SUBJECT: Forwards request for changes to App A of Tech Spec for License DPR-74. Changes cover: fire detection instrumentation emergency core cooling sys. & turbine overspeed protection.

February 13, 1979
AEP:NRC:00111

Donald C. Cook Nuclear Plant Unit No. 2
Docket No. 50-316
License DPR No. 74

PROPOSED REVISIONS TO THE
DONALD C. COOK NUCLEAR PLANT UNIT NO. 2
APPENDIX 'A' TECHNICAL SPECIFICATIONS

FIGURE 3.4-2

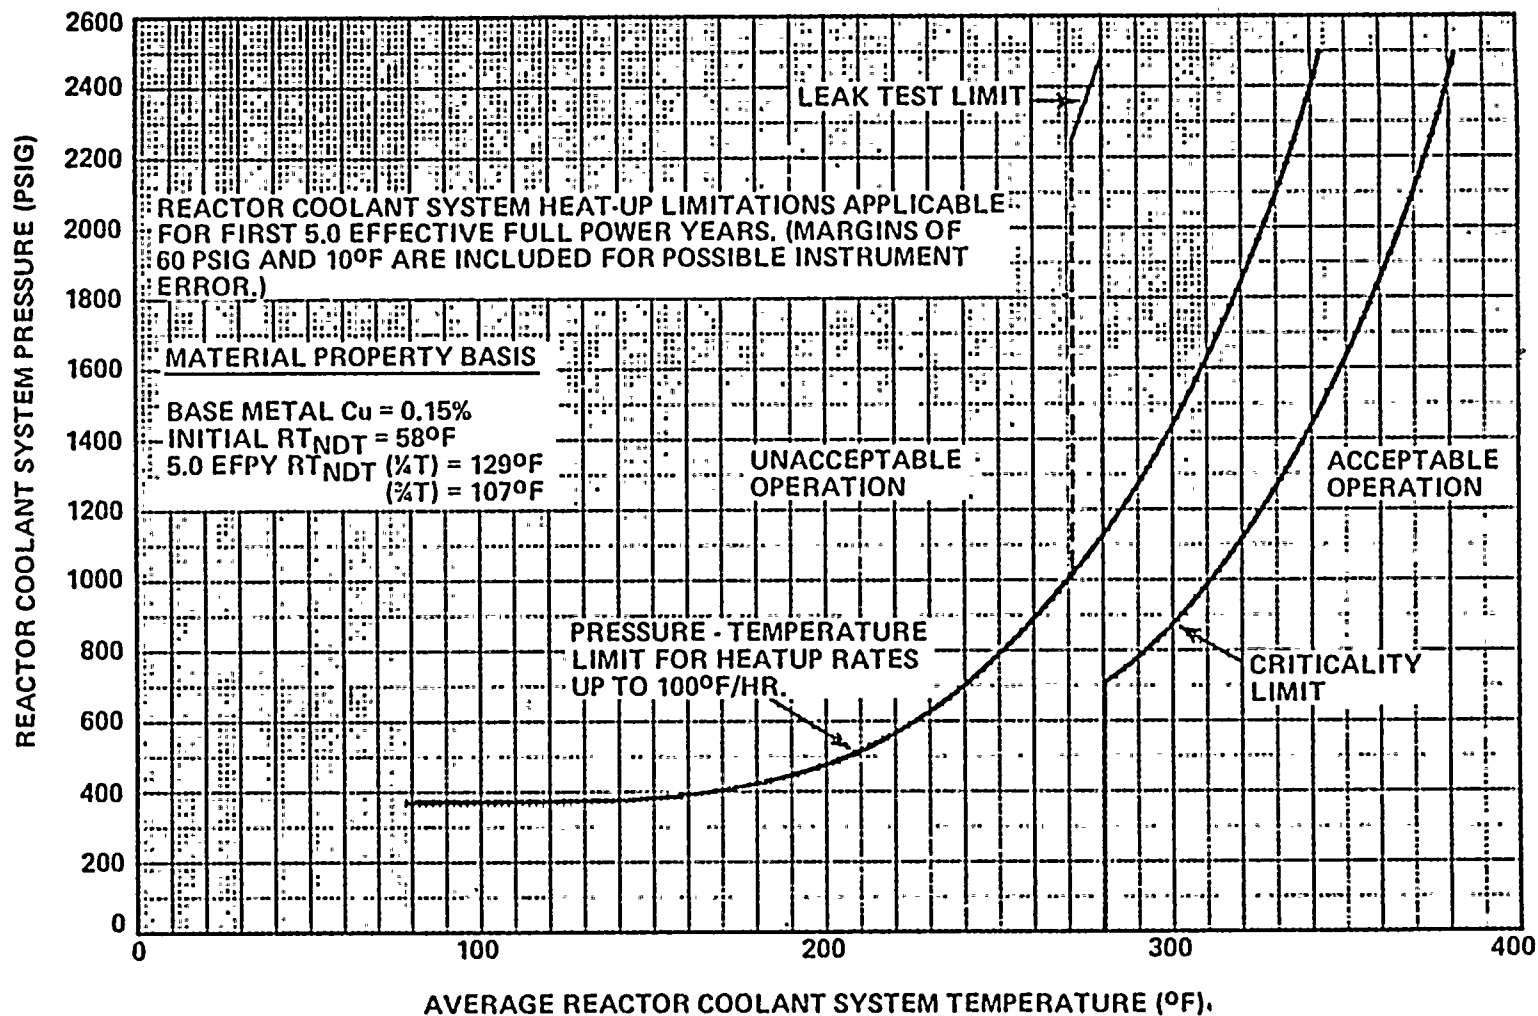
This change involves a revision to Figure 3.4-2 on page 3/4 4-25. The curve shown for the Reactor Coolant System limiting heatup rate is for a maximum rate of 100⁰F/Hr. and the caption at the bottom of the page indicates 60⁰F/Hr. This change is editorial in nature and is shown in the attached revised page 3/4 4-25. This change will not adversely affect the health and safety of the public.

REACTOR COOLANT SYSTEM PRESSURE - TEMPERATURE LIMITS VERSUS 100°F/Hour Rate - CRITICALITY LIMIT AND HYDROSTATIC TEST LIMIT

FIGURE 6.2.2 Facility Organization - Donald C. Cook - Unit No. 2

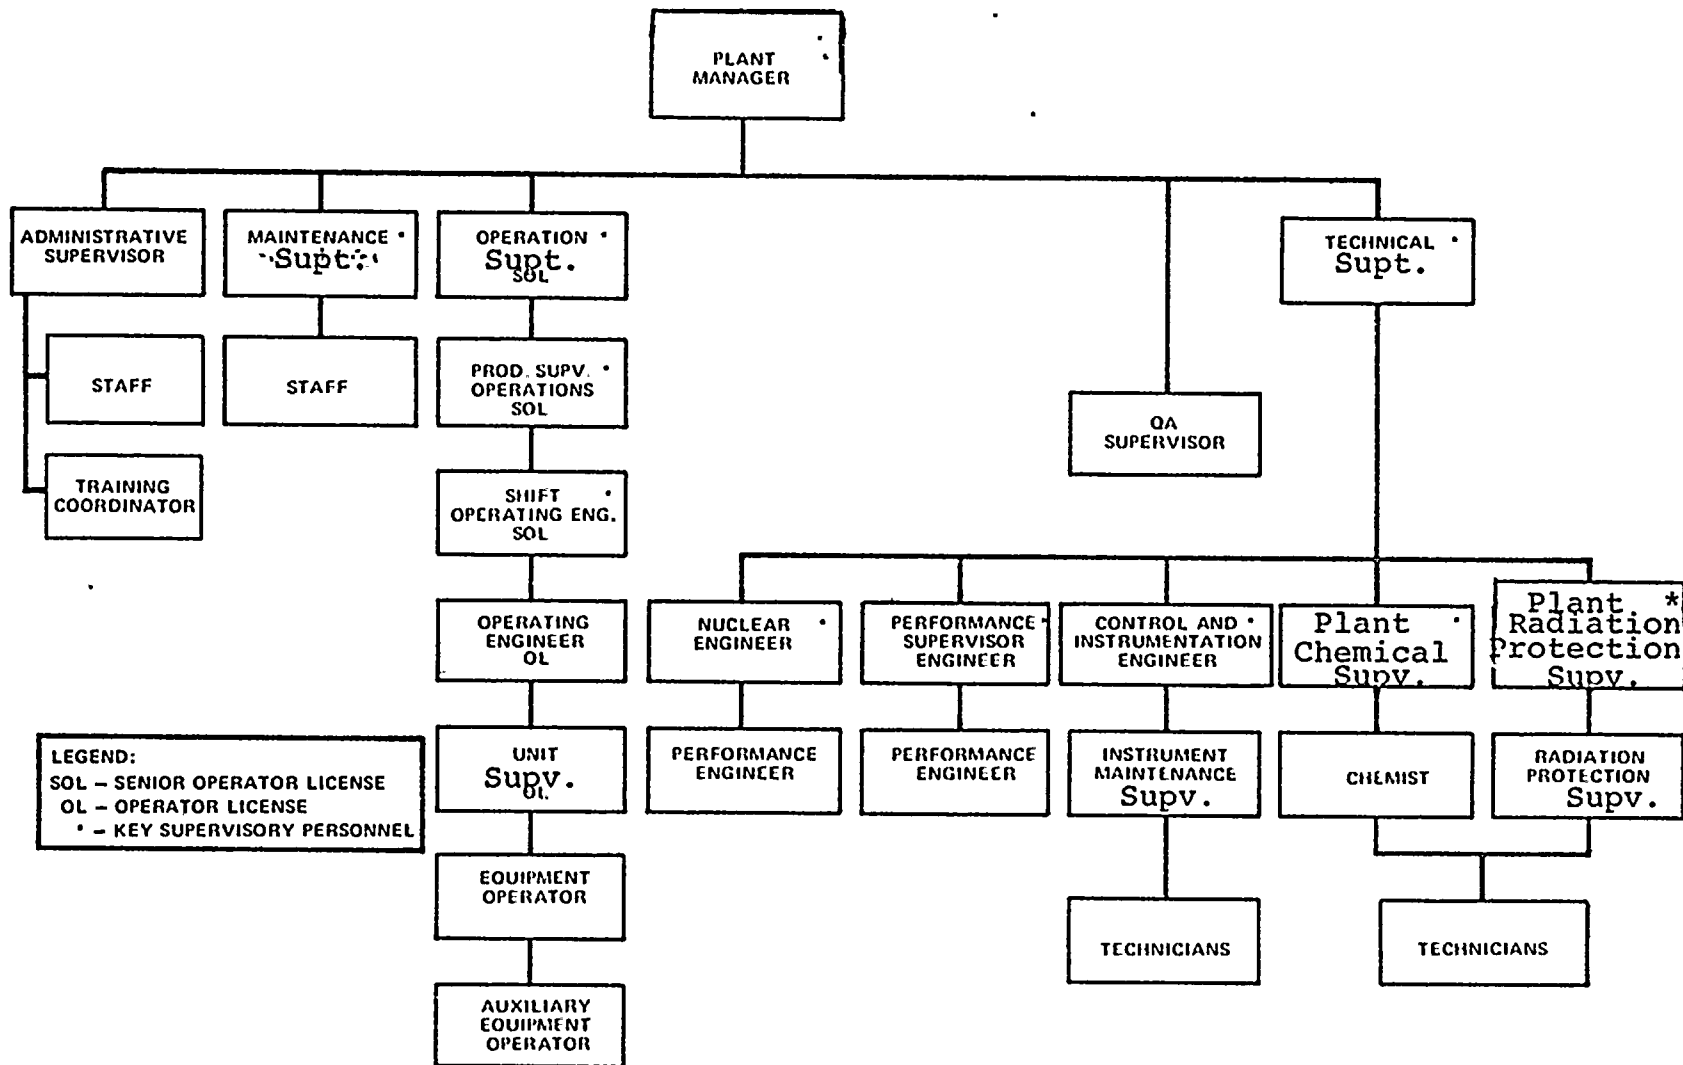
This change involves a revision to Figure 6.2-2 "Facility Organization" (Page 6-3) and Table 6.2-1 (Page 6-4). We have had a system wide change in the titles of the staff members of our operating plant. Certain "Foremen" are now "Supervisors" and "Supervisors" are now "Superintendents." The attached figure 6.2-2 has been revised accordingly.
